**Appl. No.** : **10/671,179**  
**Filed** : **September 25, 2003**

### **AMENDMENTS TO THE DRAWINGS**

## **REMARKS**

FIG. 2  
(PRIOR ART)

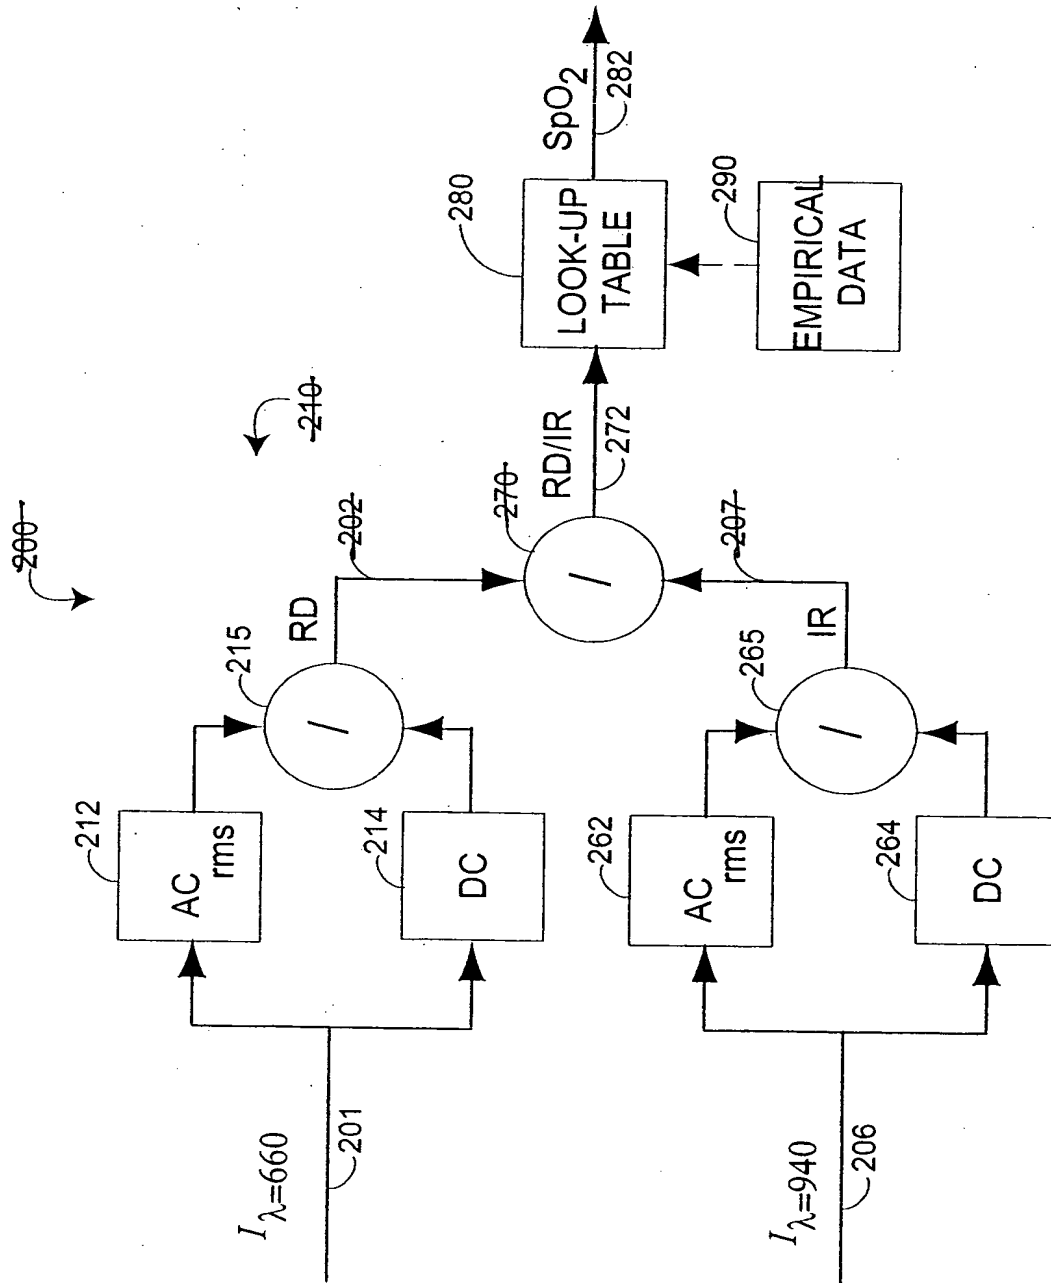
The attached sheets of drawings include changes to Figs. 2, 4, 5, and 9. The sheets, which include Figs. 1-10, replace the original sheets including Figs. 1-10. In Figure 2, reference characters 200, 202, 207, 210 and 270 have been deleted. In Figure 4, reference character 422 has been deleted. In Figure 5, reference characters 569 and 550 have been deleted and reference character 400 has been changed to 500. In Figure 9, reference character 932 has been deleted.

The Office Action dated March 3, 2006 objected to the drawings because they included reference characters not mentioned in the specification. In particular, in Figure 2, reference characters 200, 202, 207, 210, and 270 are not mentioned in the description. In Figure 4, reference character 422 was not mentioned in the description. In Figure 5, reference characters 569 and 550 were not mentioned in the description. In Figure 9, reference character 932 was not mentioned in the description. In addition, Applicant has amended Figure 5 to change reference character 400 to 500. Figures 2, 4, 5, and 9 have been replaced in the attached document entitled "*Submission Of Replacement Drawings For Approval By Examiner*," to show the above mentioned changes to the reference characters of the drawings.

FIG. 5

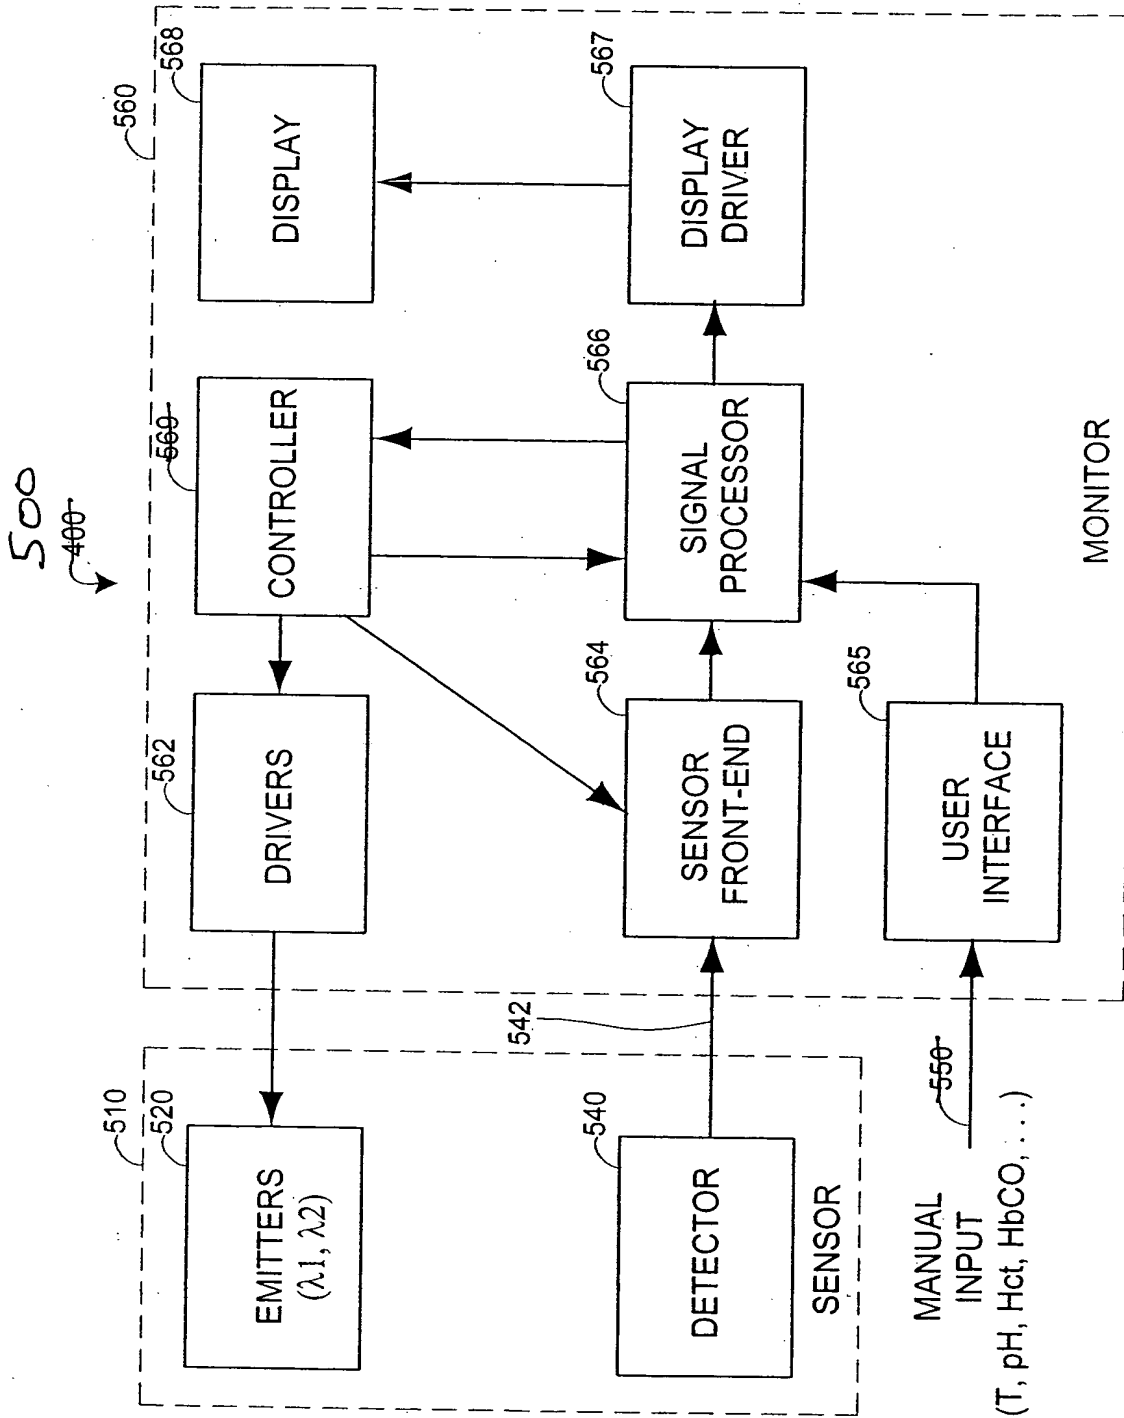
The drawing amendment to Figure 5, changing reference character 400 to 500 is supported in the description at paragraph 29. The originally filed specification states "FIG. 5 illustrates one embodiment of a parameter compensated pulse oximeter **500** having a sensor **510** and manual inputs to a monitor **560**."
